UNITED STATES PATENT AND TRADEMARK OFFICE

APPLICATION NO.	FILING DATE	FIRST NAMED INVENTOR	ATTORNEY DOCKET NO.	CONFIRMATION NO.
10/528,424	03/18/2005	Masatoshi Hada	05021	4913

Office Action Summary

Fig. 1

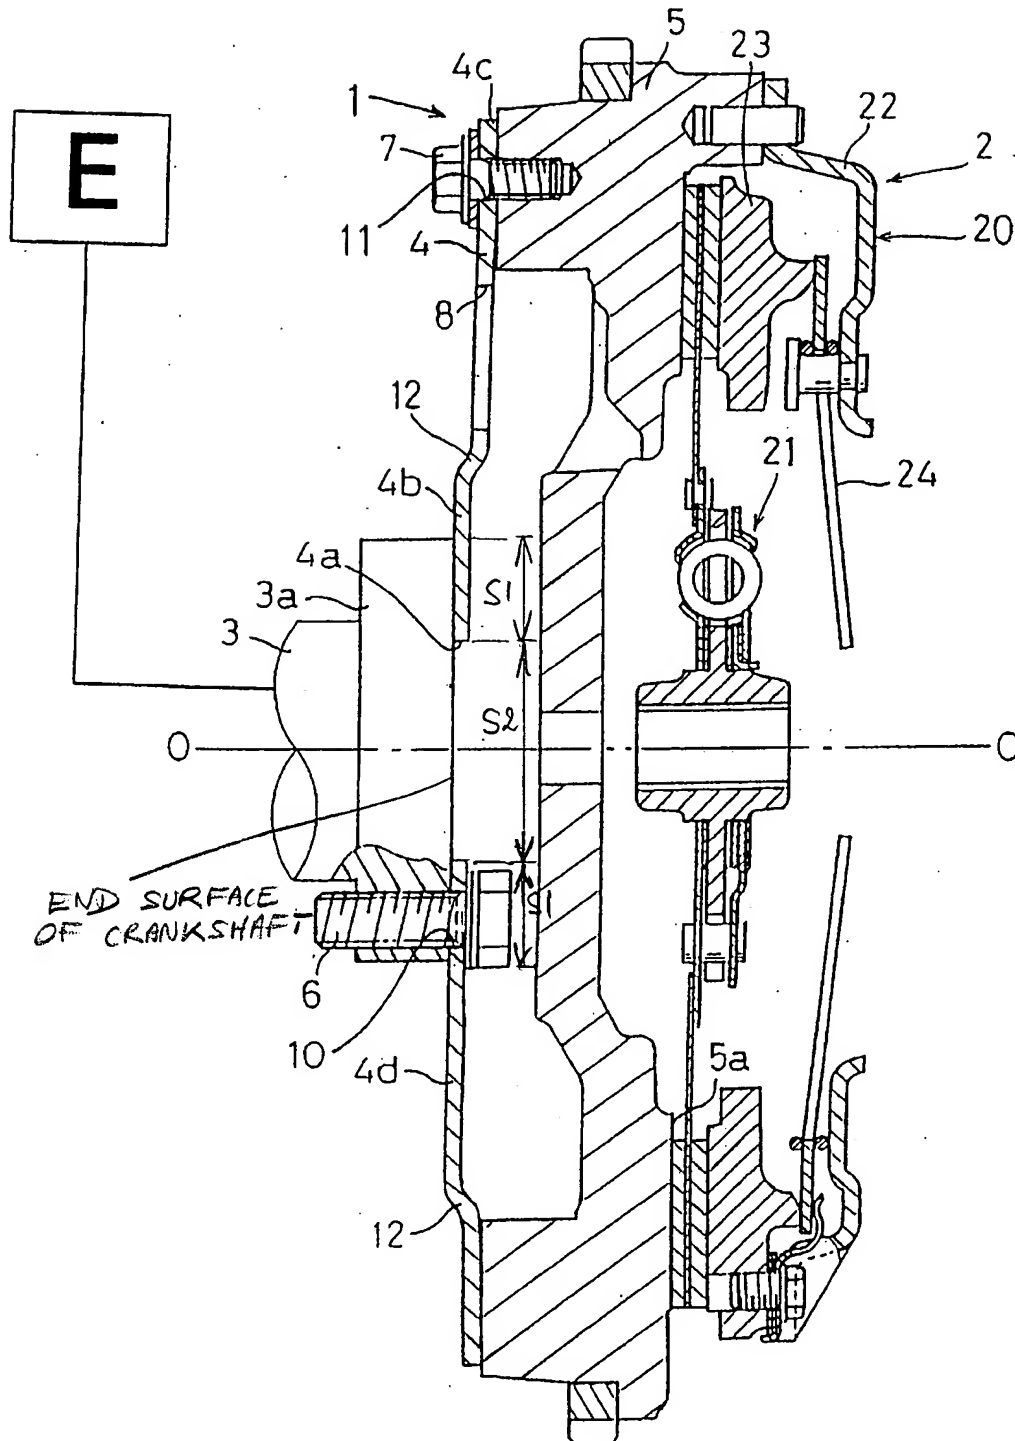
Regarding claim 1, Doman teaches a flywheel 1 in which a central part 4b, 4d of a thin plate portion 4 having a flywheel mass 5 provided on an outer peripheral side of the plate portion 4 is joined to an end surface (unnumbered. See Attachment or "Att.") of a crankshaft 3, 3a through a plurality of bolts 6 disposed annularly at intervals (Fig. 2), characterized in that, within a contact zone (S1 in Figs. 1 and 2 of Att.) of a substantially polygon (Fig. 3 of Att.) defined by

linking each center of the bolts 6 with straight lines excluding the bearing surfaces of the bolts 6, the plate portion 4 has a non-contacting part (S2 in Figs. 1 and 2 of Att.) set not to contact with the end surface of the crankshaft 3, 3a, and the area of the non-contacting part (S2) is set to be a determined percentage of the whole area of the contact zone (S1).

Regarding claim 3, the plate portion 30 is provided with a non-contacting part (at 31a in Fig. 4 of Att.) that does not contact with the end surface (Fig. 1 of Att.) of the crankshaft 3, 3a.

Fig. 3

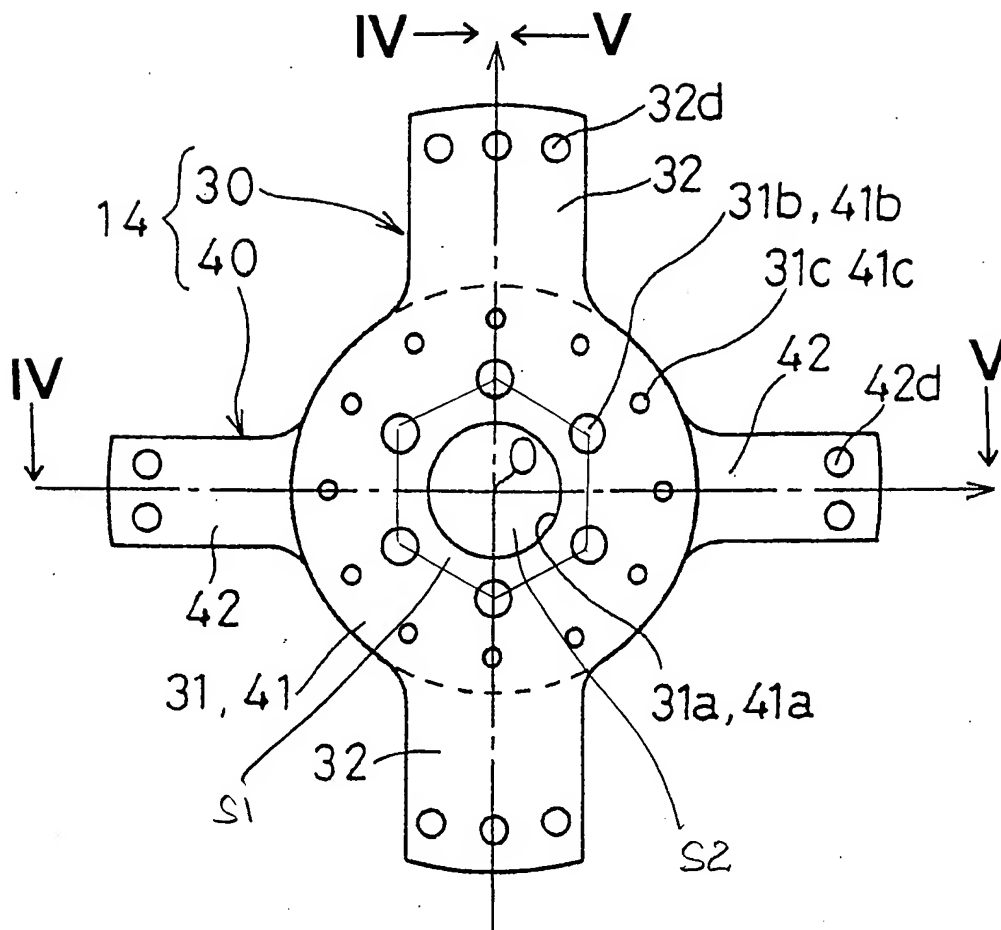
(S2 in Figs. 3 and 4 of Att.) set not to contact with the plate portion 30, and the area of the non-contacting part (S2) is set to be a determined percentage of the whole area of the contact zone.
